The Apple II Revision 07 Main Board

The main logic board of your Apple is a 'Revision 07' board. This means it is slightly different from the Apple boards which are described in the Apple II Reference Manual. It will not, however, behave differently in any specific way unless you have changes made to it. This Revision 07 board has greater flexibility than earlier boards.

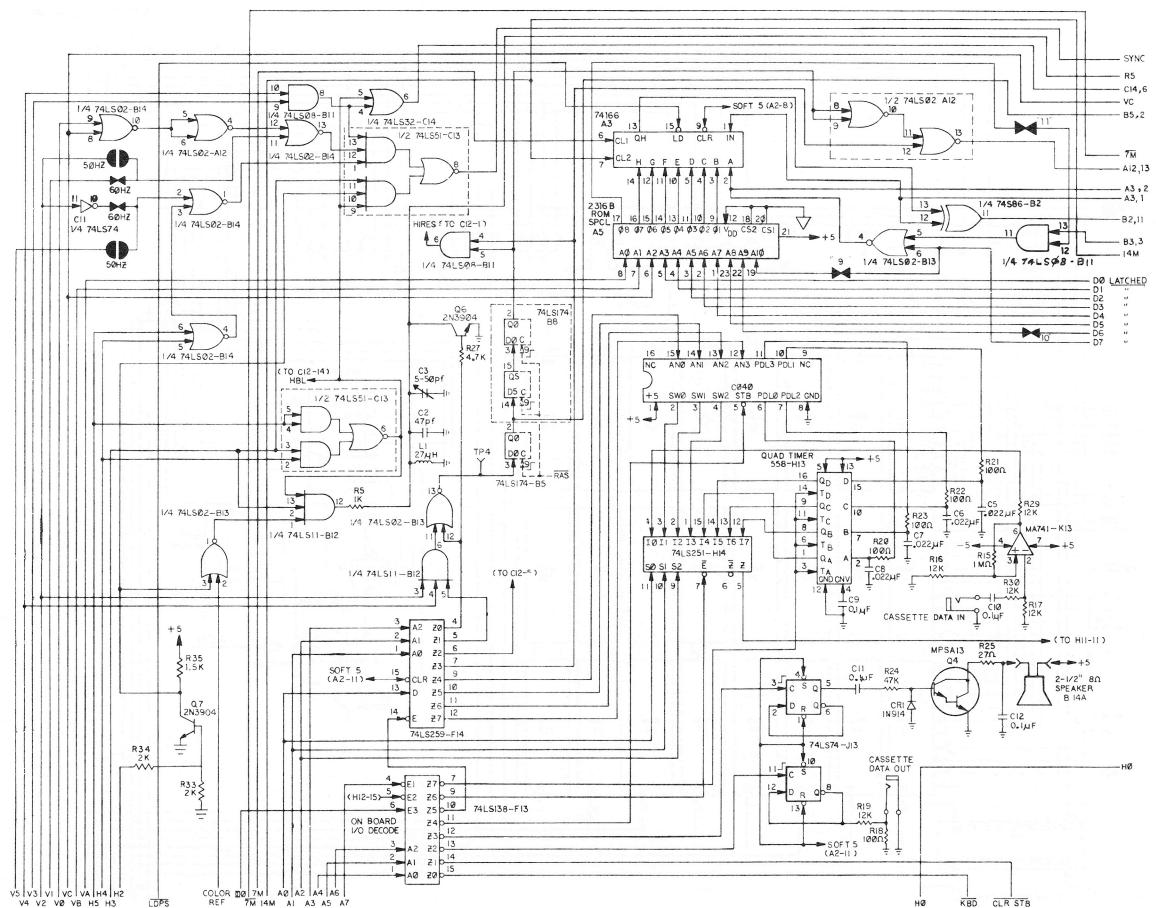
The major differences in the Revision #7 board are described below. Also, the attached schematics show the areas in which the Revision #7 board is different from earlier boards. You may wish to note these differences in your Apple II Reference manual, on the pages which correspond to the schematics here.

Replaces Figure 22-5. Schematic Diagram of the Apple II

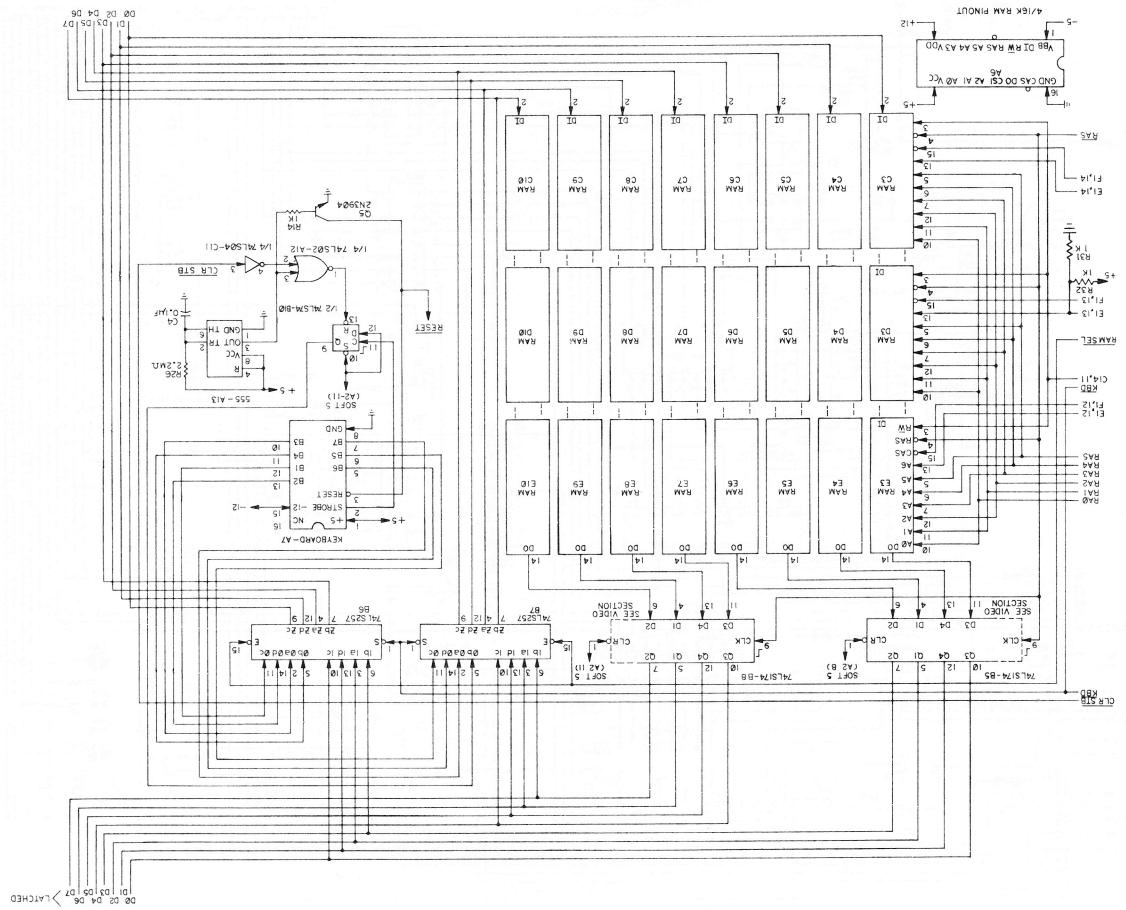
\* The Revision #7 board does not have RAM configuration blocks. This means the RAM Integrated Circuits (ICs) which give your Apple its memory MUST be 16K byte ICs. All of the RAM ICs in your Apple are within the white-outlined box on the board. If you add memory to your Apple, make sure all the ICs are 16K bytes.

\* The IC which controlled the configuration blocks in the older versions of the Apple II board is no longer there. It was formerly in the E2 position on the Apple board (in the row labeled E, the second IC from the

- \* The Revision #7 board has a different character generator ROM IC. The character generator ROM IC determines what style of lettering, or character set, you'll see on your monitor or terminal screen. The new character generator ROM is found next to the Keyboard socket on the main board. This 2316B ROM has much more ROM (Read Only Memory) space than the former 2513 character generator ROM, so it's possible to have more than one character set available. The 2316B ROM can also be replaced with a 2716 EPROM, which allows you to program and change your character sets.

- \* An inverter circuit has been added in the H2 line, which is a video synchronization signal. This alters the video synchronization pulse rate of the Apple so that is more compatible with modern TVs that have digital synchronization circuitry.

- \* Two 1K resistors have been added on address line A6 to reduce noise in that line of RAM.
